## RESOLUTION MEPC.141(54)

**AMENDMENTS TO THE ANNEX OF THE PROTOCOL OF 1978 RELATING TO  
THE INTERNATIONAL CONVENTION FOR THE PREVENTION OF  
POLLUTION FROM SHIPS, 1973****(Amendments to regulation 1, addition to regulation 12A, consequential amendments  
to the IOPP Certificate and amendments to regulation 21 of the revised  
Annex I of MARPOL 73/78)**

**AMENDMENTS TO THE REVISED MARPOL ANNEX I**

**Figure 1 – Oil fuel tank boundary lines for the purpose of paragraph 6**

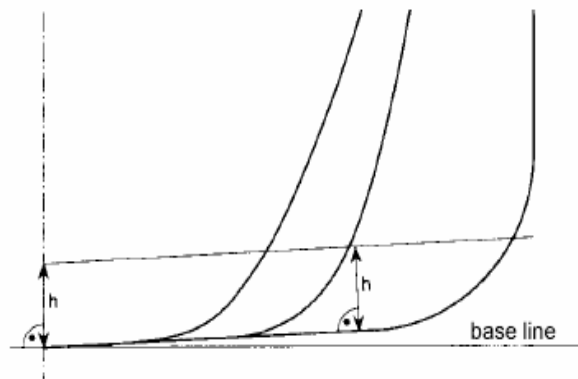
6 For ships, other than self-elevating drilling units, having an aggregate oil fuel capacity of  $600 \text{ m}^3$  and above, oil fuel tanks shall be located above the moulded line of the bottom shell plating nowhere less than the distance  $h$  as specified below:

$$h = B/20 \text{ m or,}$$

$$h = 2.0 \text{ m, whichever is the lesser.}$$

The minimum value of  $h = 0.76 \text{ m}$

In the turn of the bilge area and at locations without a clearly defined turn of the bilge, the oil fuel tank boundary line shall run parallel to the line of the midship flat bottom as shown in Figure 1.

**Figure 2 – Oil fuel tank boundary lines for the purpose of paragraphs 7 and 8**

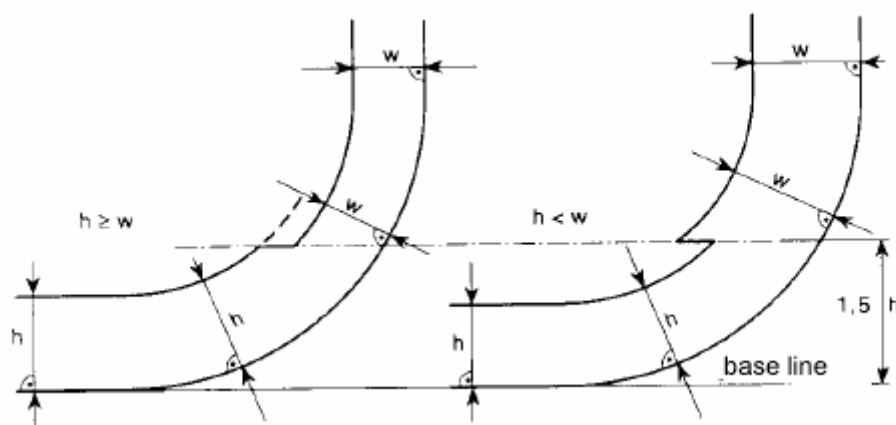
7 For ships having an aggregate oil fuel capacity of  $600 \text{ m}^3$  or more but less than  $5,000 \text{ m}^3$ , oil fuel tanks shall be located inboard of the moulded line of the side shell plating, nowhere less than the distance  $w$  which, as shown in Figure 2, is measured at any cross-section at right angles to the side shell, as specified below:

$$w = 0.4 + 2.4 C/20,000 \text{ m}$$

The minimum value of  $w = 1.0 \text{ m}$ , however for individual tanks with an oil fuel capacity of less than  $500 \text{ m}^3$  the minimum value is  $0.76 \text{ m}$ .

8 For ships having an aggregate oil fuel capacity of  $5,000 \text{ m}^3$  and over, oil fuel tanks shall be located inboard of the moulded line of the side shell plating, nowhere less than the distance  $w$  which, as shown in Figure 2, is measured at any cross-section at right angles to the side shell, as specified below:

$$w = 0.5 + C/20,000 \text{ m or}$$

$$w = 2.0 \text{ m, whichever is the lesser.}$$

The minimum value of  $w = 1.0 \text{ m}$

**Figure 3 – Dimensions for calculation of the minimum oil outflow for the purpose of subparagraph 11.5.3.3**

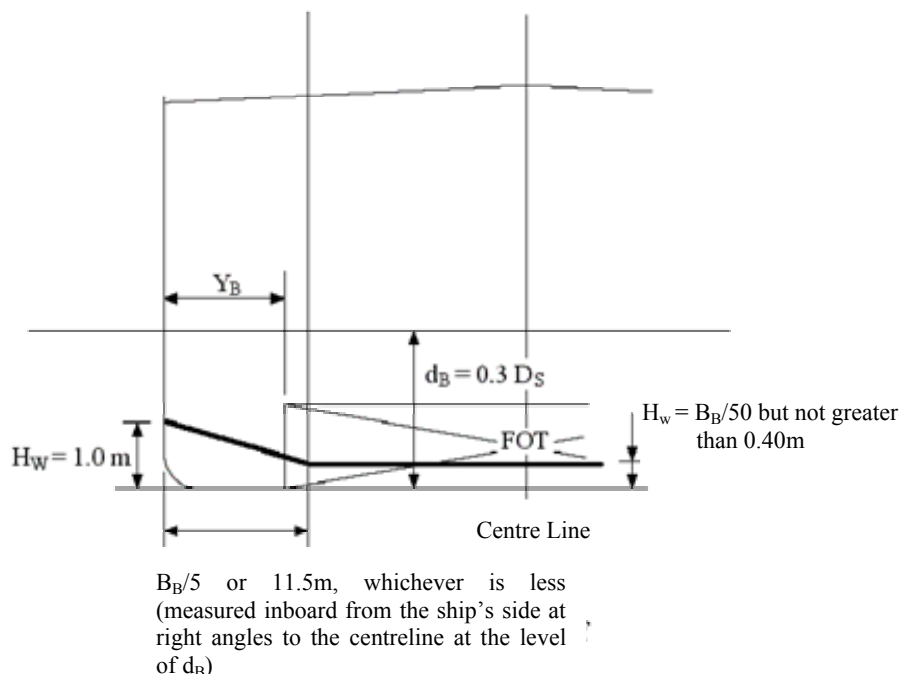
.3 The oil outflow  $O_{B(i)}$  for any tank bounding the bottom shell plating shall be taken not less than the following formula, but no more than the tank capacity:

$$O_{B(i)} = H_W \cdot A$$

$$H_W = 1.0 \text{ m, when } Y_B = 0$$

$$H_W = B_B/50 \text{ but not greater than } 0.4 \text{ m, when } Y_B \text{ is greater than } B_B/5 \text{ or } 11.5 \text{ m, whichever is less}$$

“ $H_W$ ” is to be measured upwards from the midship flat bottom line. In the turn of the bilge area and at locations without a clearly defined turn of the bilge,  $H_W$  is to be measured from a line parallel to the midship flat bottom, as shown for distance “ $h$ ” in Figure 1.

For  $Y_B$  values outboard  $B_B/5$  or 11.5 m, whichever is less,  $H_W$  is to be linearly interpolated.

$Y_B$  = the minimum value of  $Y_B$  over the length of the oil fuel tank, where at any given location,  $Y_B$  is the transverse distance between the side shell at waterline  $d_B$  and the tank at or below waterline  $d_B$ .

$A$  = the maximum horizontal projected area of the oil fuel tank up to the level of  $H_W$  from the bottom of the tank.
